SECTION 75 W APPLICATION - ACCESSIBILITY REVIEW

Commercial and Retail Development

100 Mount Street, North Sydney

Report No: AN09015 Cap Stat Report

PLAN - LEVEL 1 AMENITY

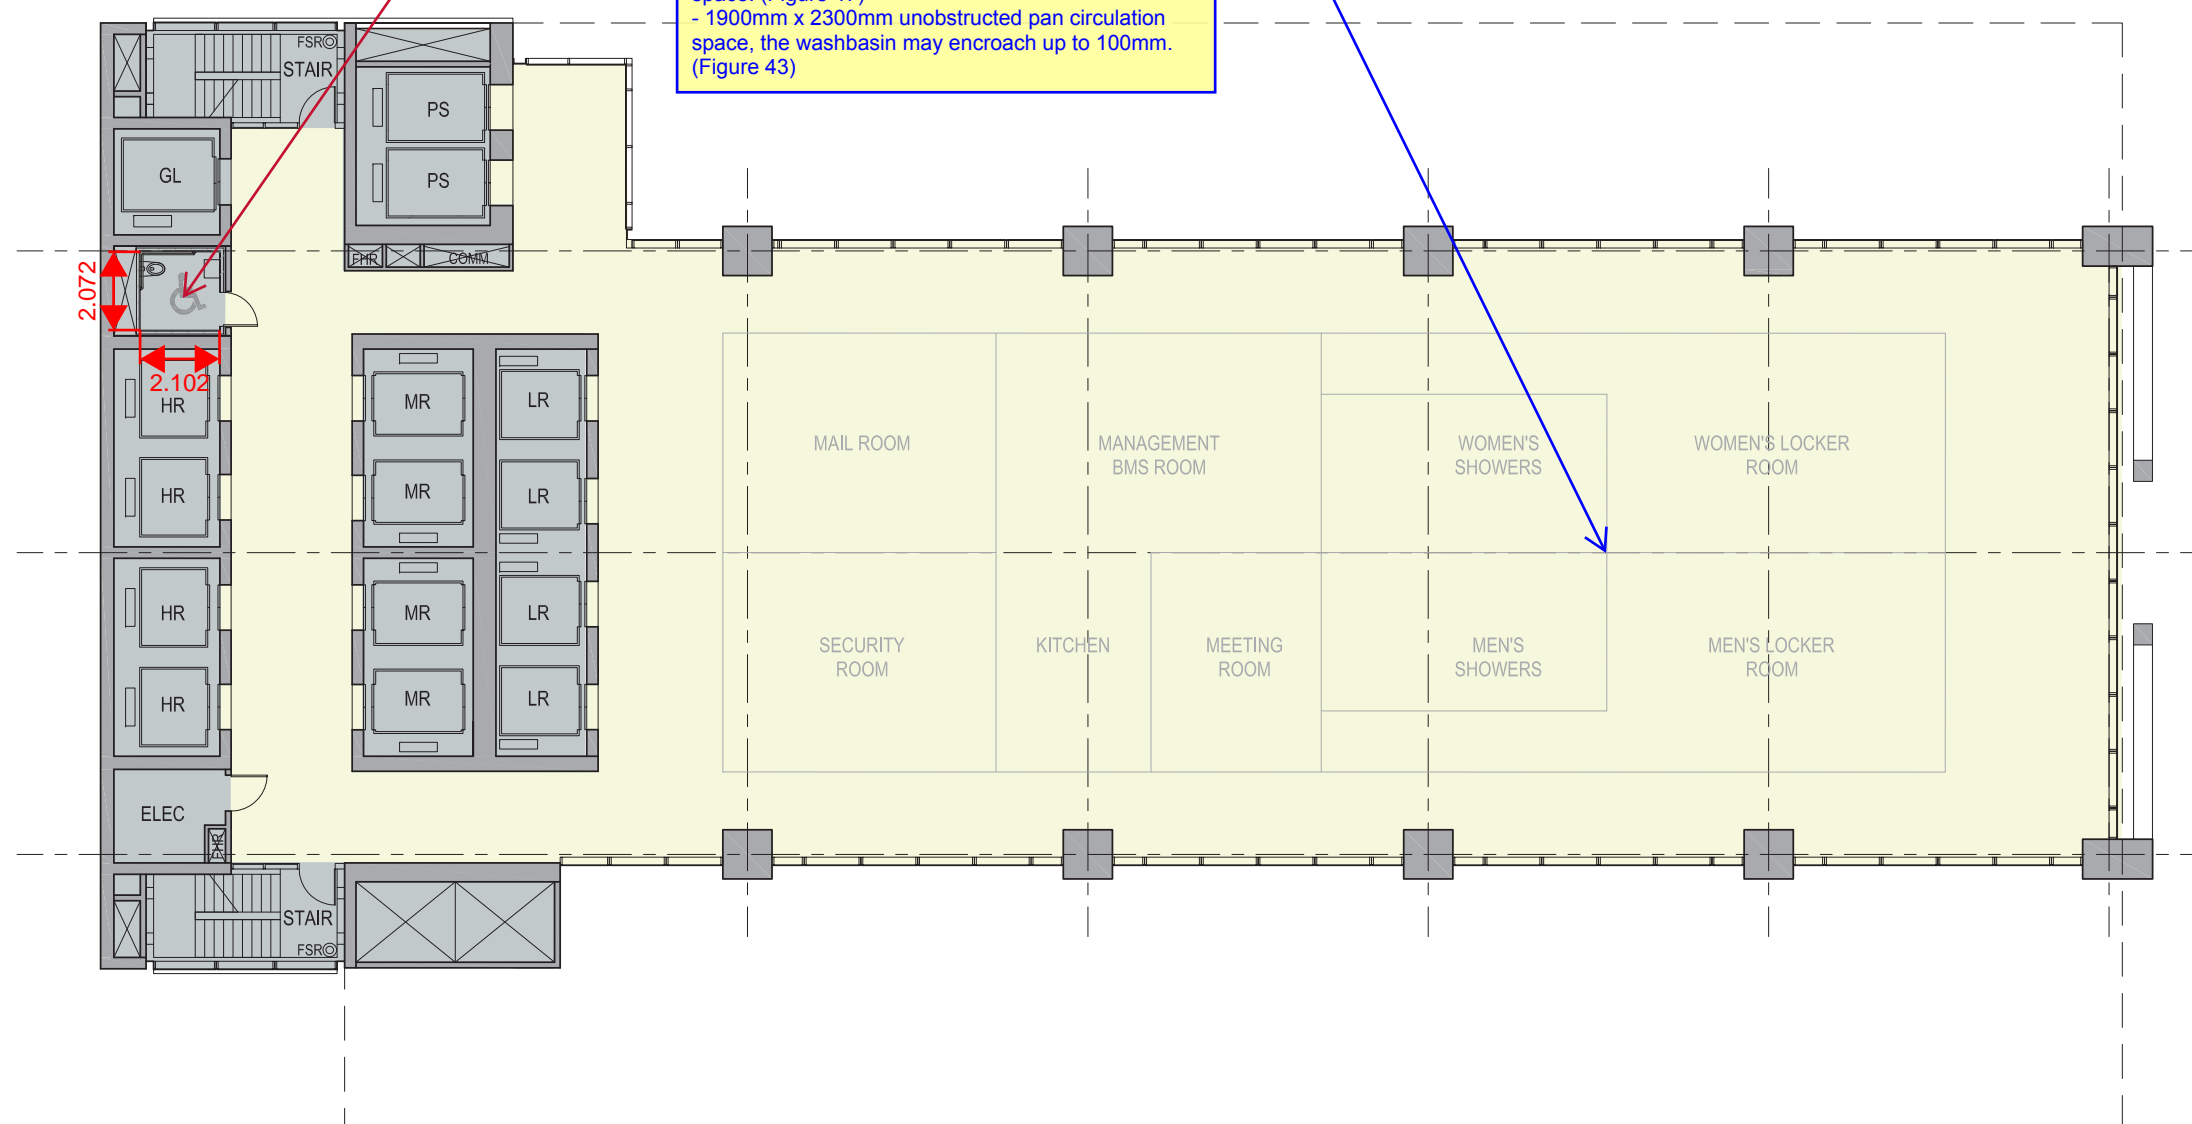
Sanitary facility shall be designed to AS1428.1-2009, Clause 15.2. Right and Left handed mirror image facility shall be located on alternating floors. BCA, F2.4(g)

Provide an accessible shower within a unisex sanitary facility. The facility should be 2400mm x 2700mm to accommodate (AS1428.1-2001):
- 1100mm x 1160mm shower recess, (Figure 47)
- 1600mm x 2350mm unobstructed shower circulation space, (Figure 47)
- 1900mm x 2300mm unobstructed pan circulation space, the washbasin may encroach up to 100mm. (Figure 43)

PLAN - TYPICAL LOW-RISE LEVEL

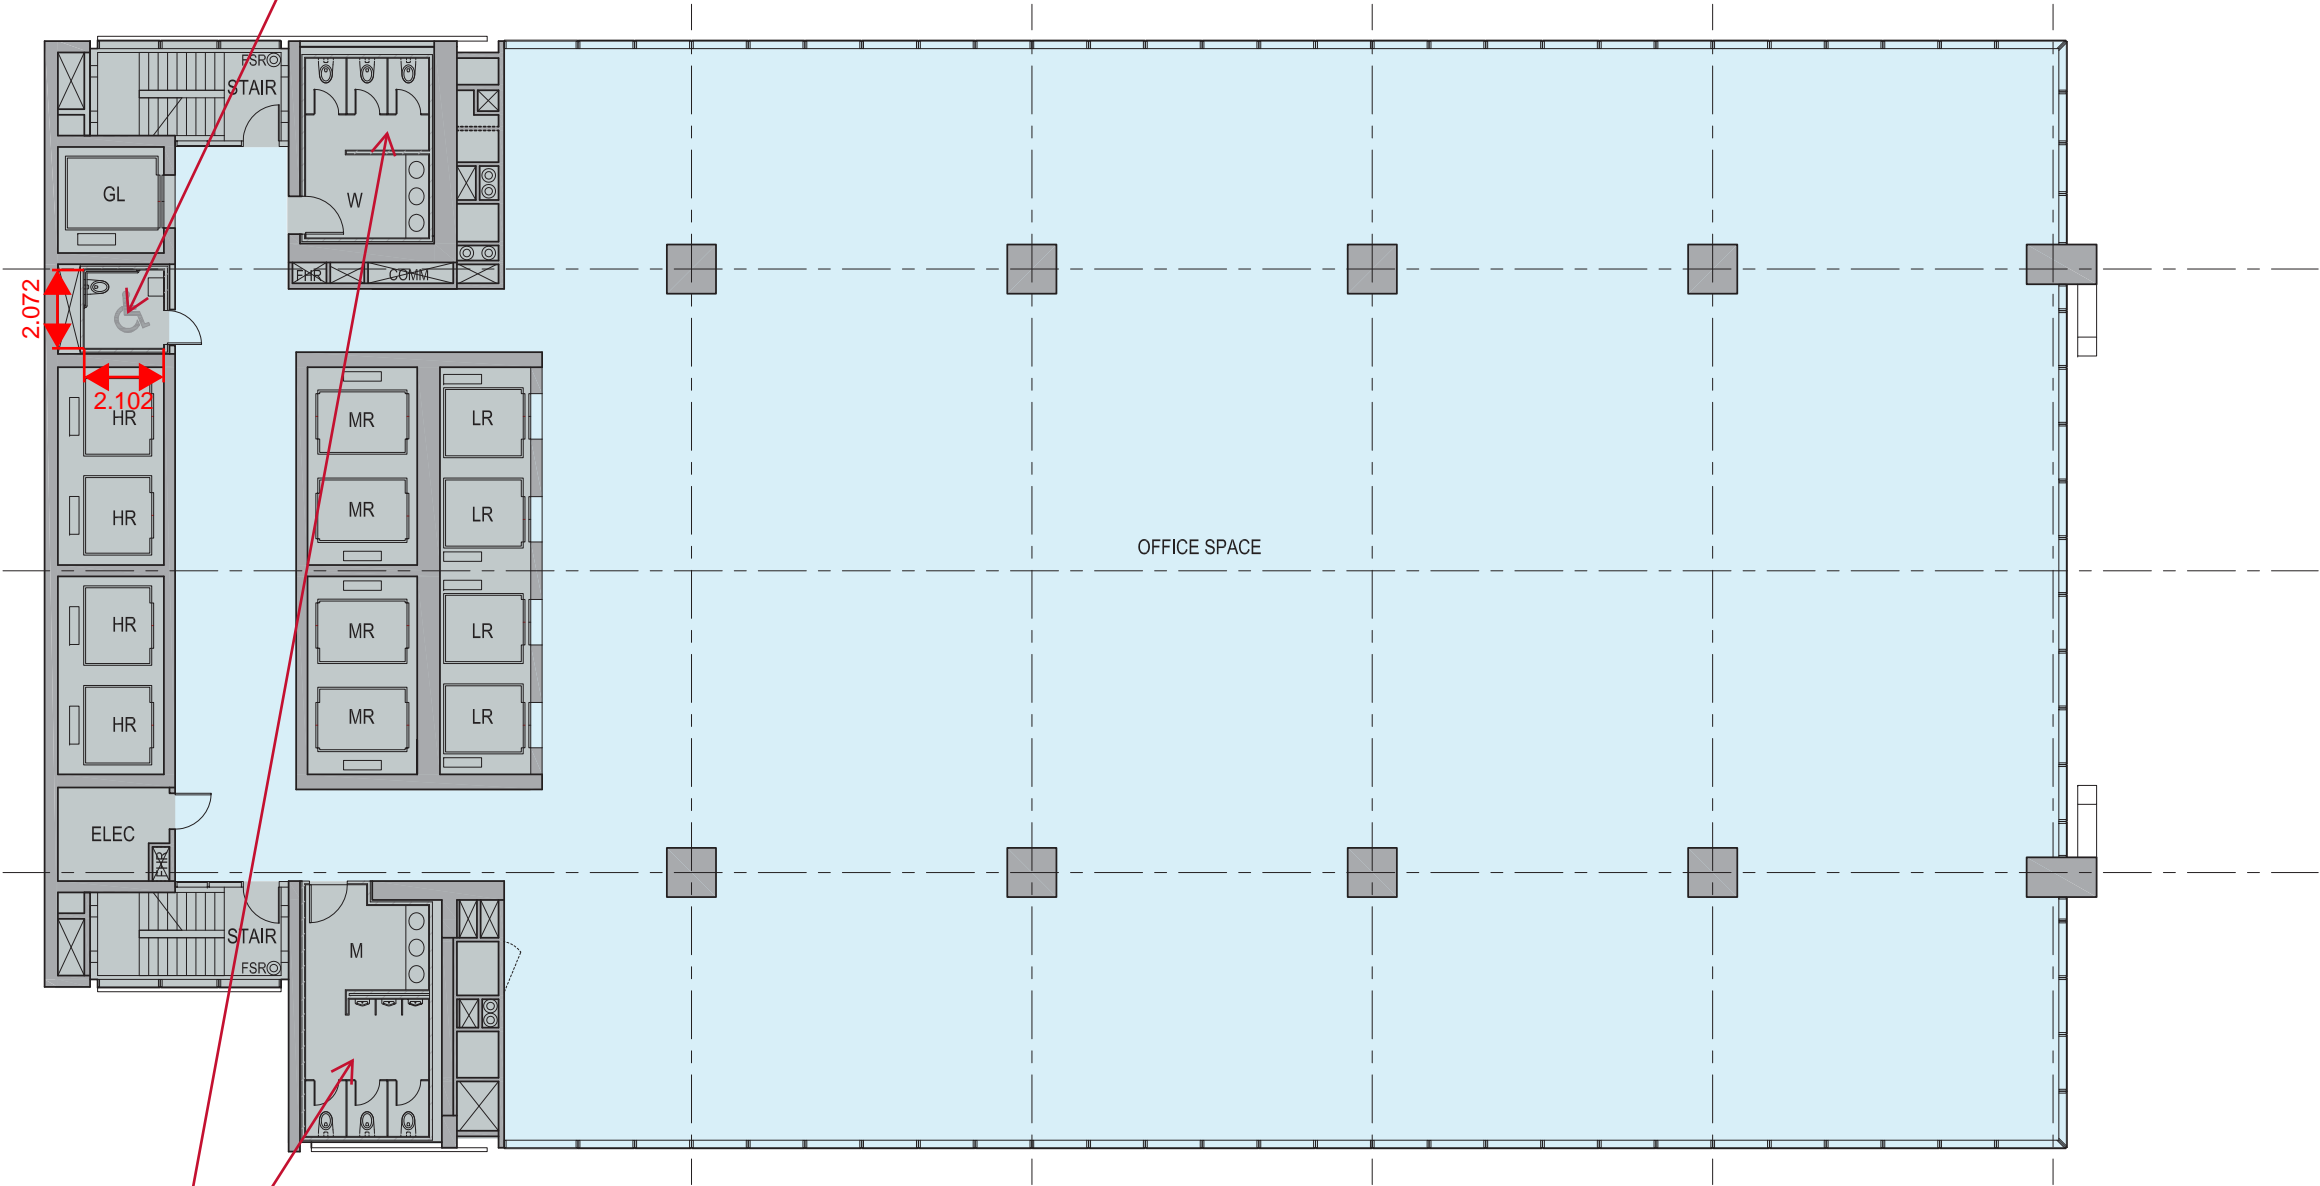
Provide unisex accessible sanitary facility. Typically 2100mm x 2700mm in order to achieve clearance to the pan of 1900mm x 2300mm. The washbasin may not encroach greater than 100mm into this space. Right and left handed mirror image facility shall be located on alternating floors. BCA, F2.4(g)

One ambulant compartment shall be provided in both the mens and womens sanitary facility. Ambulant compartments must be 900-920mm in width with a 900x900mm circulation space in front of the pan. doorway opening shall be a minimum of 700mm and not encroach on the circulation space. AS1428.1-2009, Clause 16.

PLAN - TYPICAL MID-RISE LEVEL

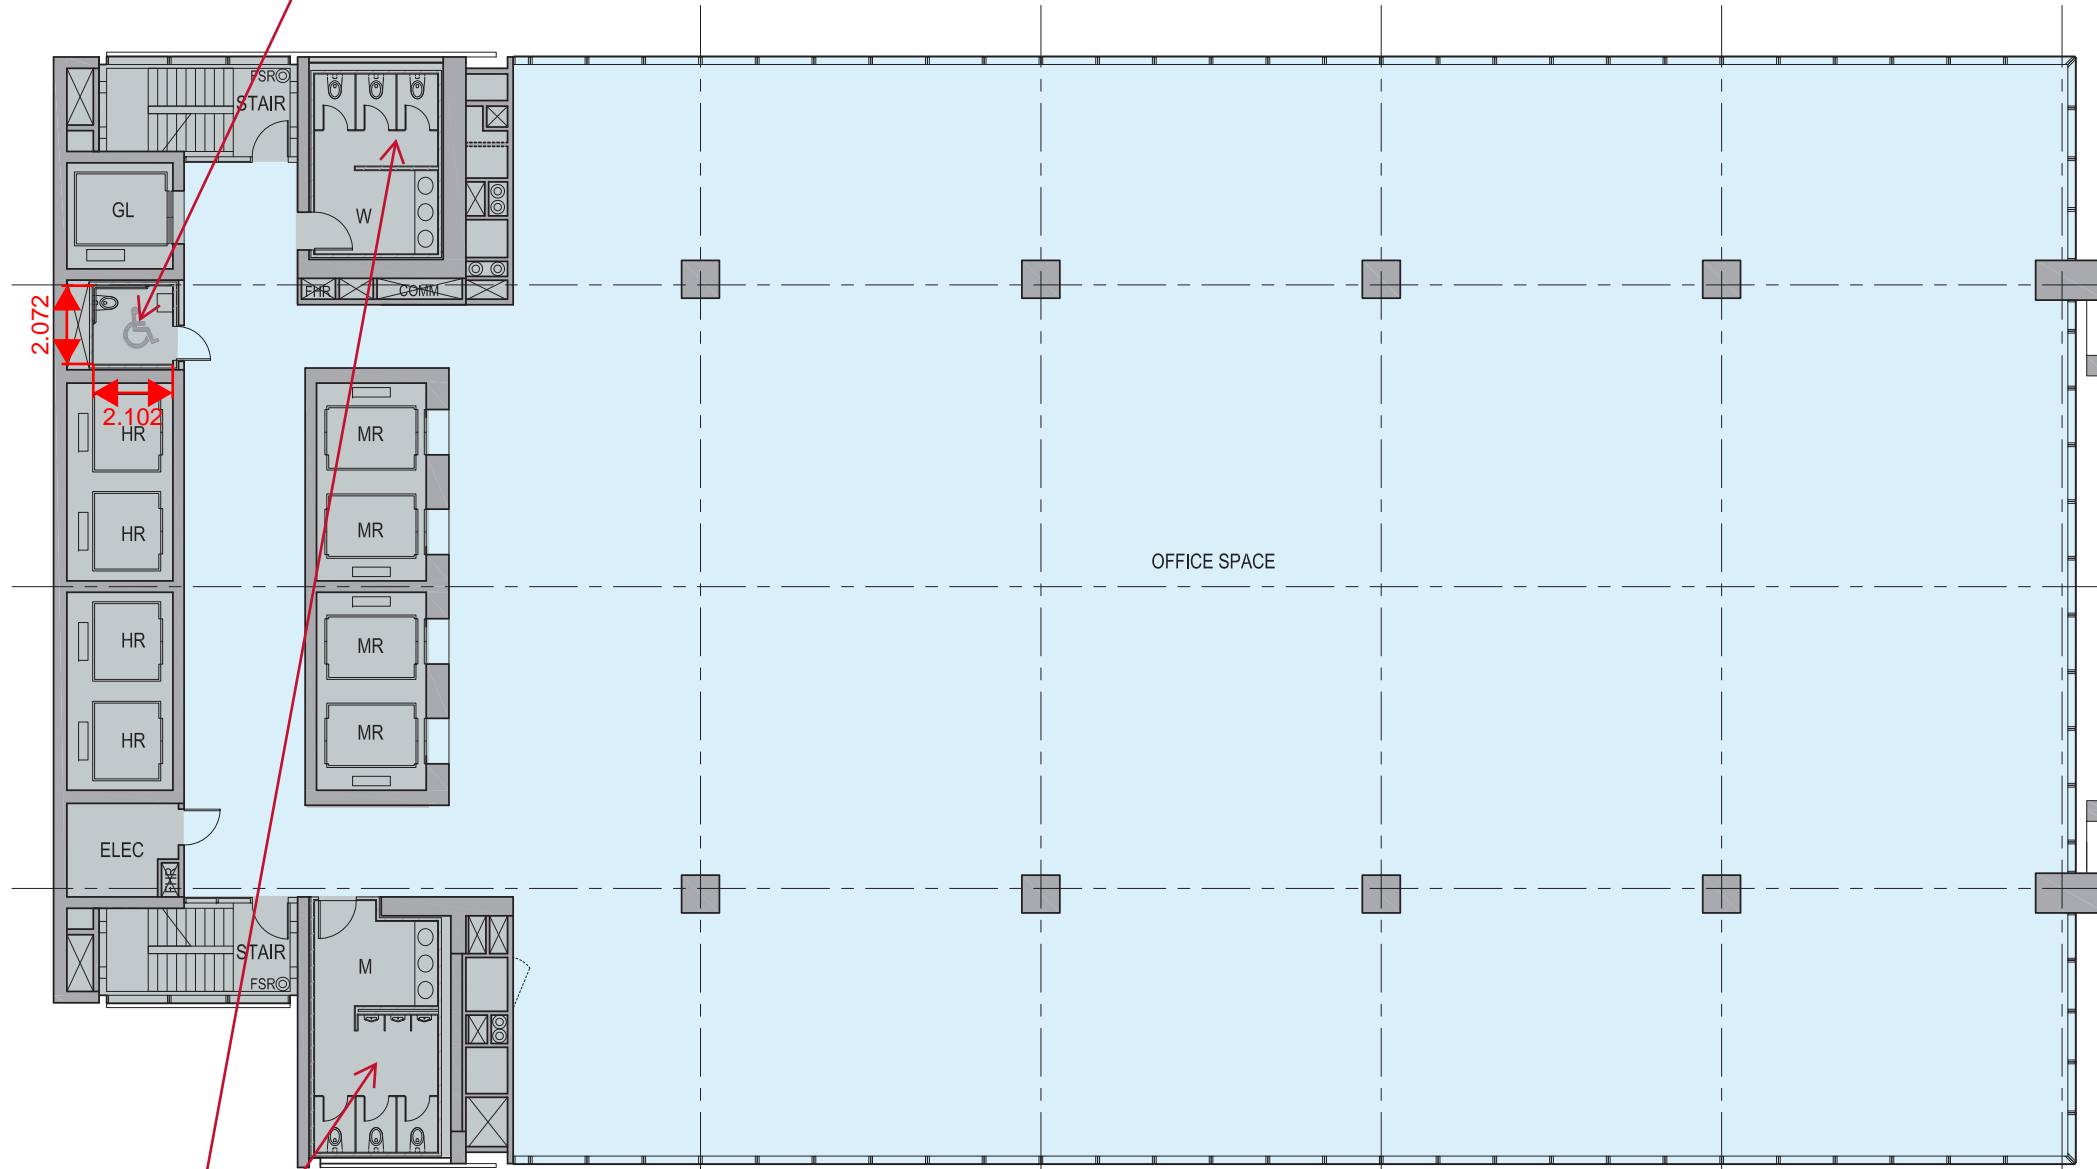
Provide unisex accessible sanitary facility. Typically 2100mm x 2700mm in order to achieve clearance to the pan of 1900mm x 2300mm. The washbasin may not encroach greater than 100mm into this space. Right and left handed mirror image facility shall be located on alternating floors. BCA, F2.4(g)

One ambulant compartment shall be provided in both the mens and womens sanitary facility. Ambulant compartments must be 900-920mm in width with a 900x900mm circulation space in front of the pan. doorway opening shall be a minimum of 700mm and not encroach on the circulation space. AS1428.1-2009, Clause 16.

PLAN - TYPICAL HIGH-RISE LEVEL

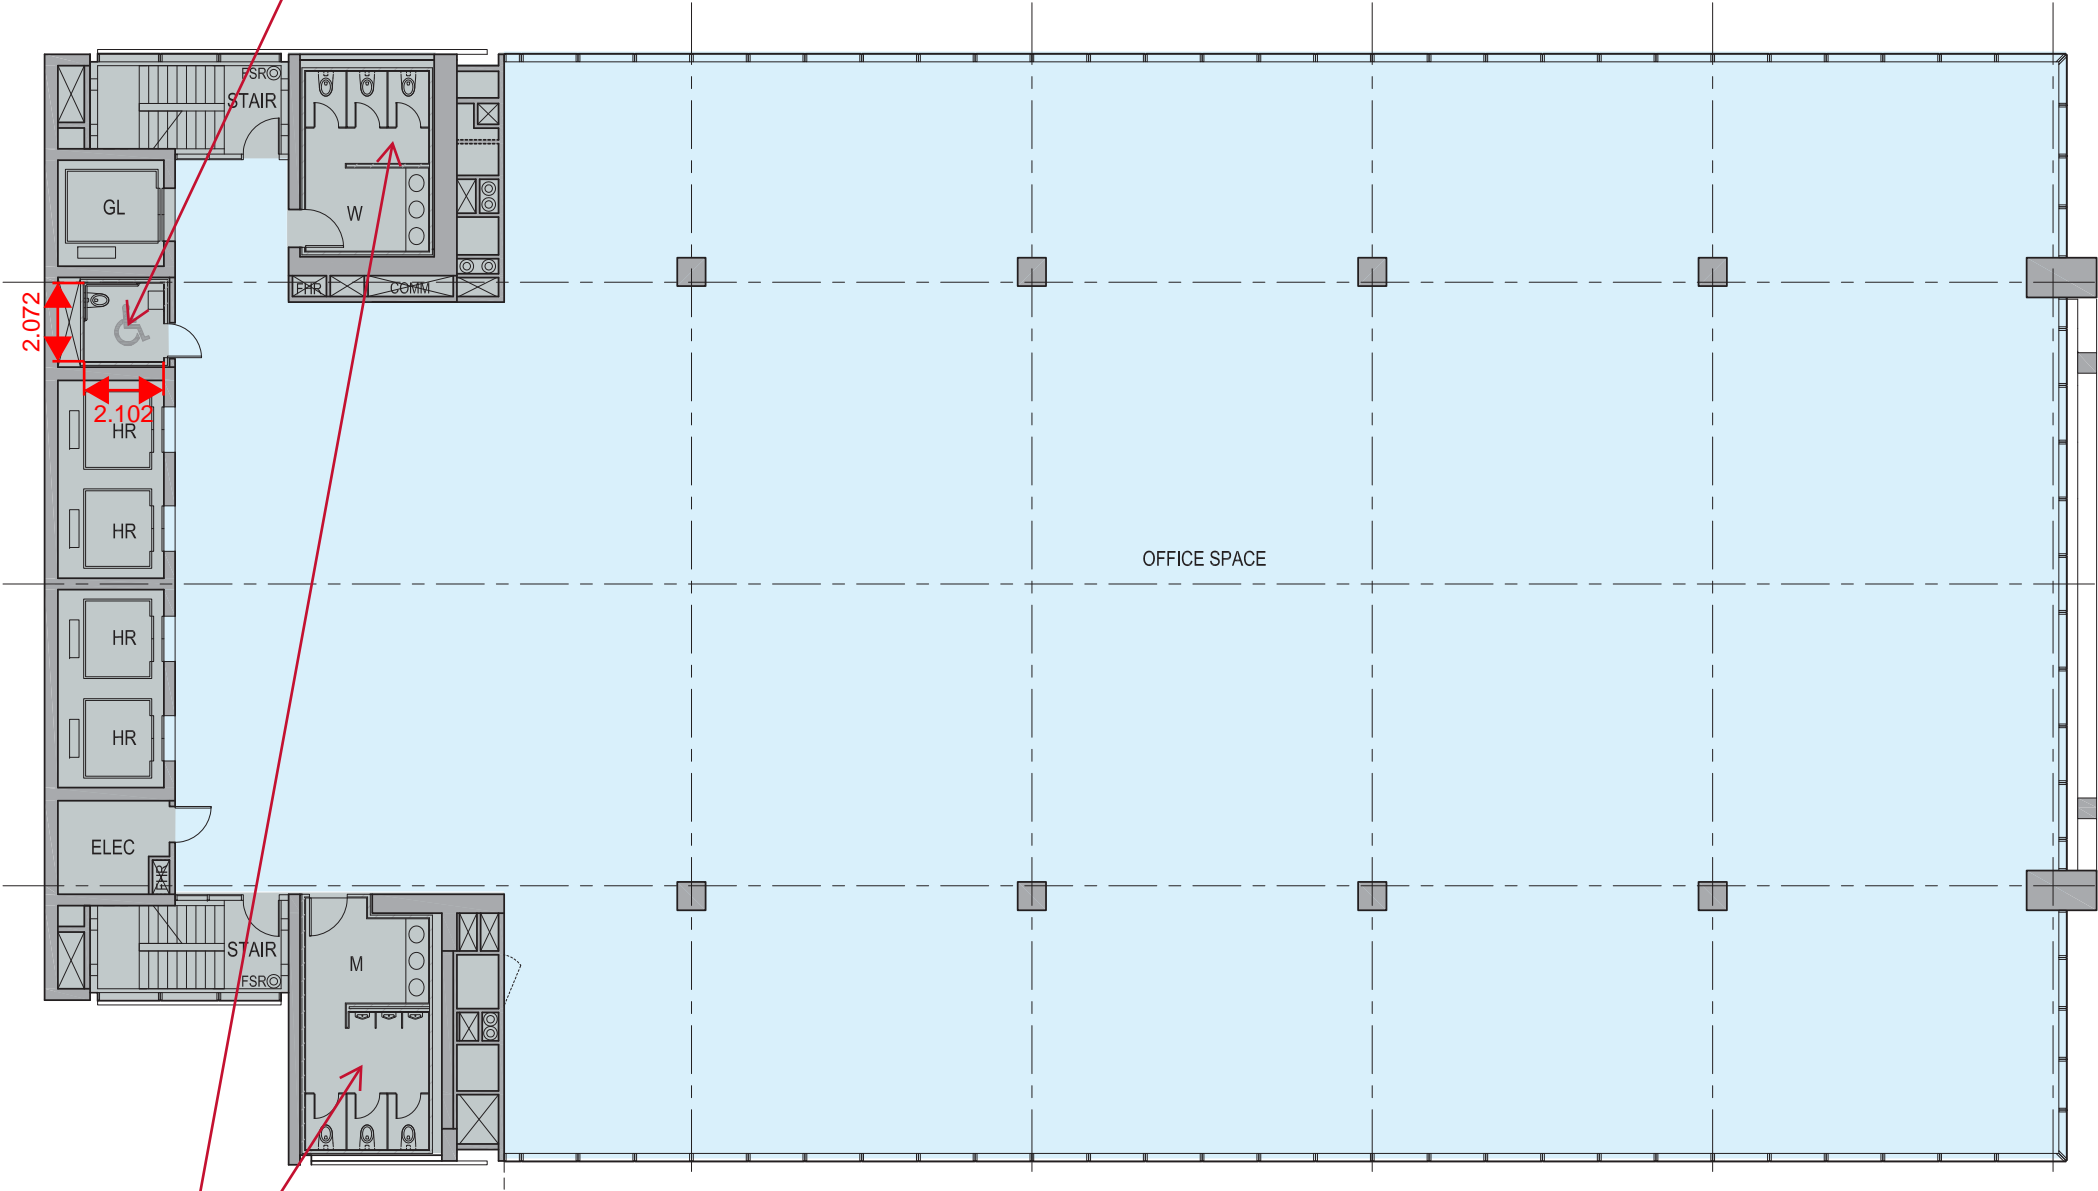
Provide unisex accessible sanitary facility. Typically 2100mm x 2700mm in order to achieve clearance to the pan of 1900mm x 2300mm. The washbasin may not encroach greater than 100mm into this space. Right and left handed mirror image facility shall be located on alternating floors. BCA, F2.4(g)

One ambulant compartment shall be provided in both the mens and womens sanitary facility. Ambulant compartments must be 900-920mm in width with a 900x900mm circulation space in front of the pan. doorway opening shall be a minimum of 700mm and not encroach on the circulation space. AS1428.1-2009, Clause 16.
